SUBJECT: **PROJECT NO. TR066664-(5)**
CSD MODIFICATION NO. 201000004
OAK TREE PERMIT NO. 200900048
TENTATIVE TRACT MAP NO. 066664
AGENDA ITEM NO. 5: JANUARY 19, 2011

COUNTY OF LOS ANGELES
DEPARTMENT OF PUBLIC WORKS
LAND DEVELOPMENT DIVISION – SUBDIVISION
TRACT NO. 66664 (Rev.)

TENTATIVE MAP DATED 12-08-2010
EXHIBIT MAP DATED 12-08-2010

SITE PLAN
 SC: 1" = 60'

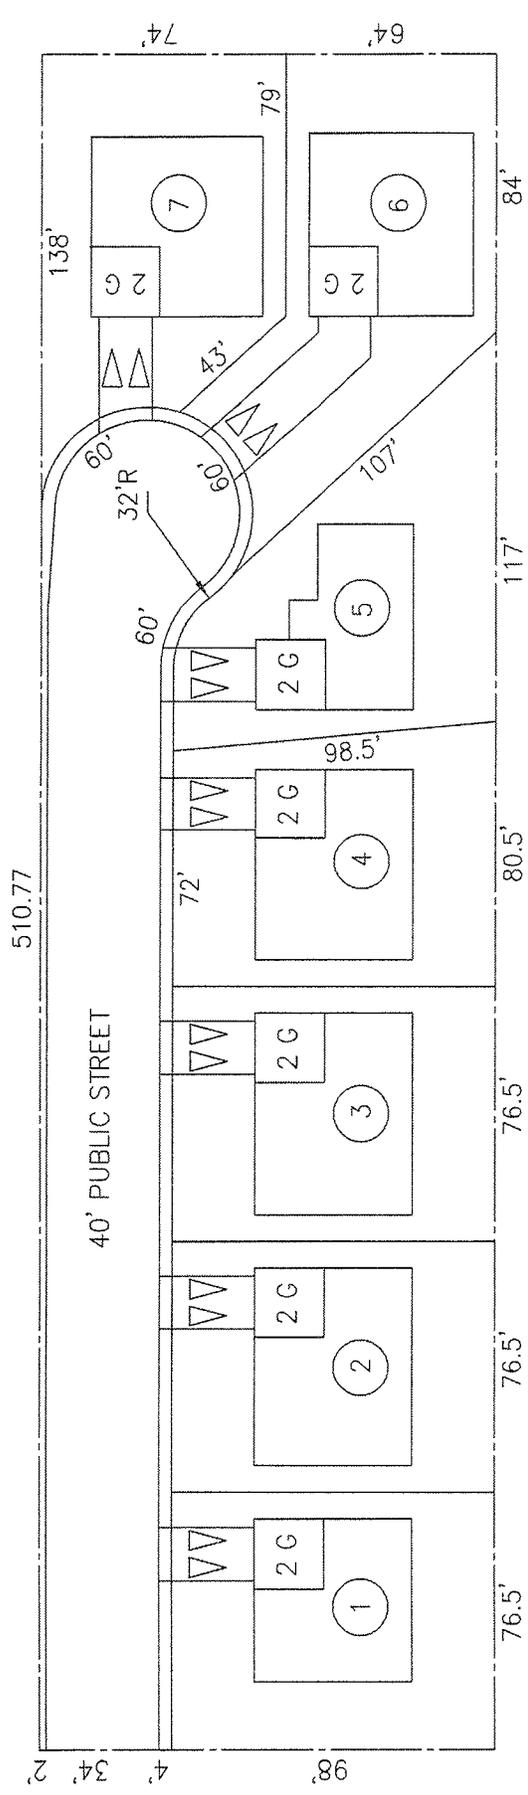
It wasn't clear whether the Developer was planning to live in one of the units. Or, is he just planning to make money off of just screwing up our neighborhood? I don't mean to sound so nasty, but 7 lots seems excessive in light of the current conditions.
